SAFETY RECALL NOTICE

McLaren Voluntary Safety Recall Inspect and Replace If Necessary, Certain Brake Flexi Hose Banjo Bolts

Bulletin type:	Safety Recall Campaign
Reference number:	SRC 00 C 001
Affected vehicles:	McLaren 570S, McLaren GT, McLaren 600LT, McLaren 720S
Attention:	All Retailer Staff
Situation:	Voluntary Safety Recall - Potential for brake flexi hose banjo bolt(s) to have been incorrectly manufactured
Procedure:	Please refer to the information outlined in this document to remove and inspect each brake flexi hose banjo bolt at each brake calliper and replace it if it is found to be incorrectly manufactured
Date:	26 th August 2021

3a. OK Condition

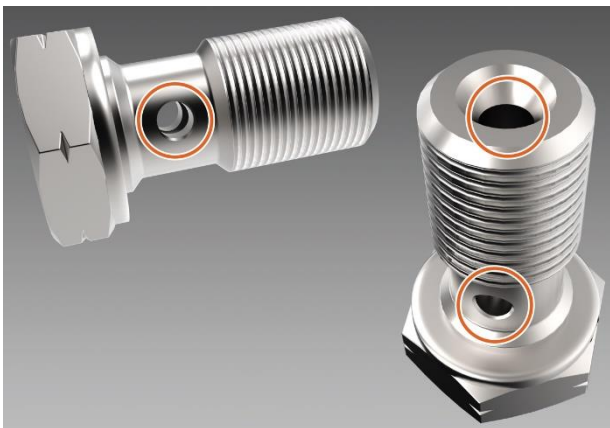
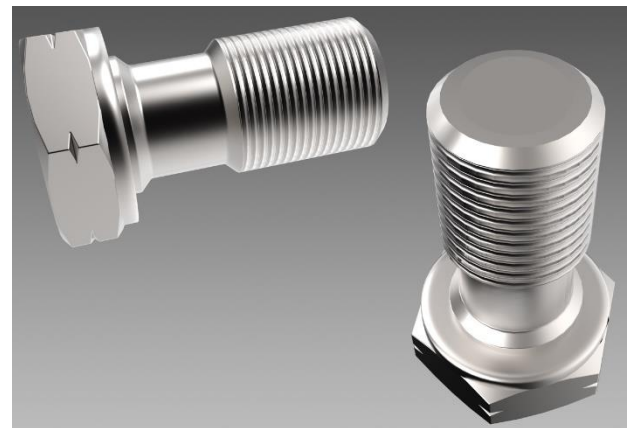
1. Secure/Lift vehicle on platform
2. Remove all wheels
3. Remove and Inspect each banjo bolt for the brake flexi hose connection at each brake calliper:
 - a. If holes are present as per image '3a, OK condition', re-install bolt with new washers and torque bolt to specification as per SIS for the respective model
 - b. If holes are NOT present as per image '3b, NOT OK condition', replace the bolt (new washers are included with the bolt) and torque to specification as per SIS for the respective model
4. Perform brake bleed procedure as per SIS for the respective model
5. Install all wheels and torque to specification as per SIS for the respective model
6. Check functionality

If a bolt is replaced due to not being manufactured correctly (holes not present), the removed part(s) must be retained and stored according to the standard McLaren Warranty policy. There is no requirement to retain the washer(s) replaced during the check procedure.
